Rinn Rua Hotel & Leisure Park, Co. Kerry

Proposed Tourism Development,
Reenroe, Ballinskelligs, Co. Kerry

Stage 1 & 2 Road Safety Audit

May 2024

Fig 2.1

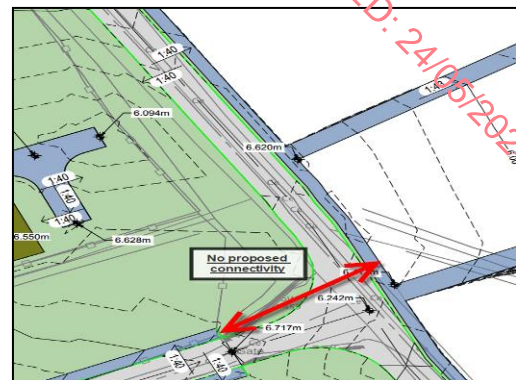
No specific pedestrian facilities have been shown linking between the development footpath at Junction 2 and the proposed footpath on the local access road. Failure to provide dedicated pedestrian access at this location could lead to pedestrians walking onto trafficked lanes to access the public road and potentially coming into conflict with vehicles leading to potential collisions. Refer to Fig 2.1 & Photo A1.

The designer should consider including a footpath at this location linking the development to footpaths in the area. The design team should ensure that an adequate pedestrian crossing is also provided at the location.

Fig 2.2

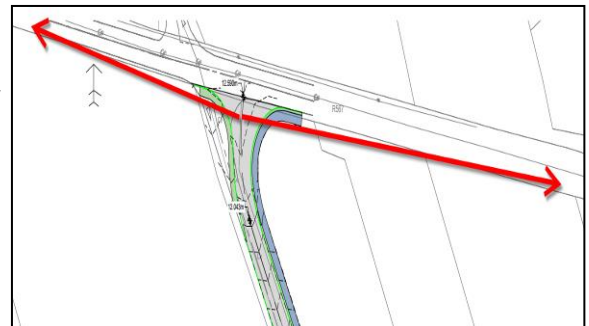
The audit team acknowledges that the realigned Junction of the local road and R567 is an improvement to the current arrangement. However, no details have been provided to the audit team as to the proposed sightlines to be provided at Junction 1. Inadequate sight lines at an entrance may lead to collisions between vehicles passing by on R567 and vehicles exiting the local road. Refer to Fig 2.2 & Photos A2 & A3.

A junction arrangement with an adequate visibility envelope is required, in accordance with the relevant standards for the road design speed. The visibility envelope should be kept clear of all obstructions such as wall, hedges, fences, signs etc and vegetation over 600mm in height.

Fig 2.3

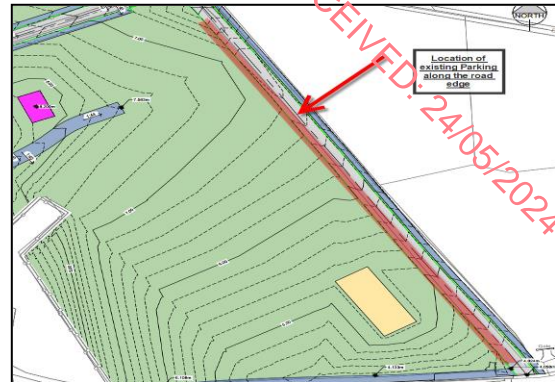
During the site visit, the audit team observed multiple people parking their vehicles along the public road while accessing the public beach. It is unclear from the drawings provided to the audit team if this existing widened roadway is being retained as part of the development. A lack of parking for members of the public accessing the beach, could lead to a road safety issue by an ad hoc nature of parking and vehicles parking on the proposed footpath. Refer to Fig 2.3 & Photos A7.

The design team should conform if the existing roadside parking is being retained as part of these works.
